Section 12A Planning Application - Request for Amendment to the Approved Lung Yeuk Tau and Kwan Tei South Outline Zoning Plan No. S/NE-LYT/19 from "Residential (Group C)" Zone and "Agriculture" Zone to "Residential (Group A) 2" Zone at Lot Nos. 755, 756, 782 S.A, 789 S.A, 789 RP, 790 S.A ss.1, 790 S.A RP, 791 S.A ss.1, 791 S.A ss.2, 791 S.A ss.3, 791 S.A RP, 791 RP, 792 S.A RP, 792 RP, 793, 794 S.A, 794 RP, 800 S.A RP, 801 S.A, 803 RP, 835 S.B ss.1 S.A, 835 S.B ss.1 RP, 836 S.A, 836 RP, 837, 838 S.A, 838 RP, 839, 840, 841 S.A, 841 S.B, 841 RP, 842 S.A, 842 S.B, 842 RP, 843, 844 S.A, 844 RP and 854 in D.D. 83 and Adjoining Government Land, Lung Yeuk Tau, New Territories

Further Information (7)

Section 12A Planning Application No. Y/NE-LYT/16

Further Information (7)
Responses-to-Comments Table
5 June 2024

Figure 5-1: Aerial Photo of Existing Structure in Site

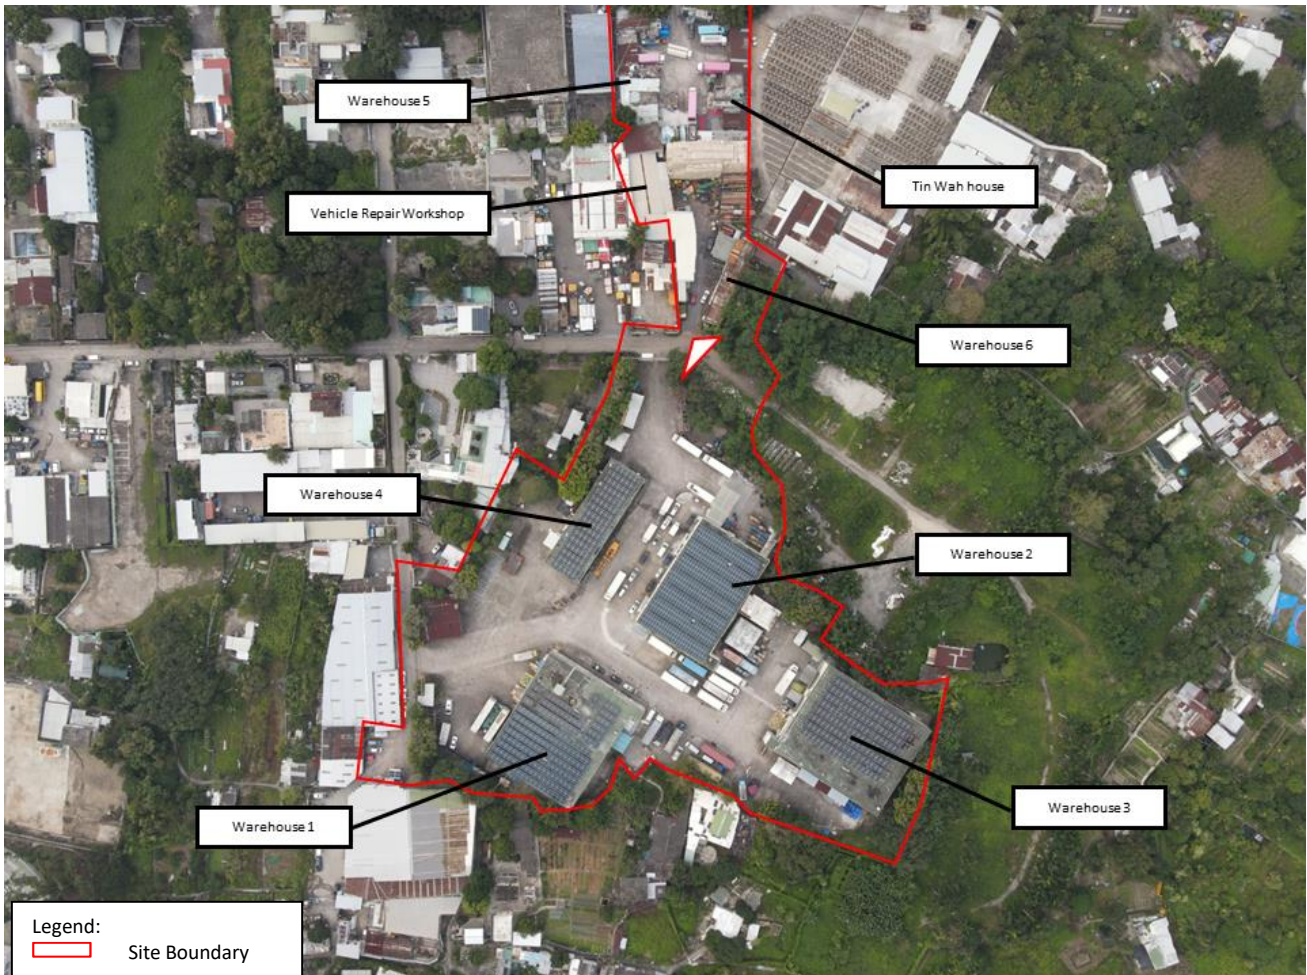
10. Response-to-Comment (13) – Figure 5.1 The site boundary on the aerial photo is incomplete; please carefully review and update the scale and extent of the figure.	Figure 5-1 is an aerial photo is taken by drone. We currently cannot obtain another aerial photo with bigger scale and higher resolution. More aerial photos from Land’s Department on the site are shown in Appendix F.
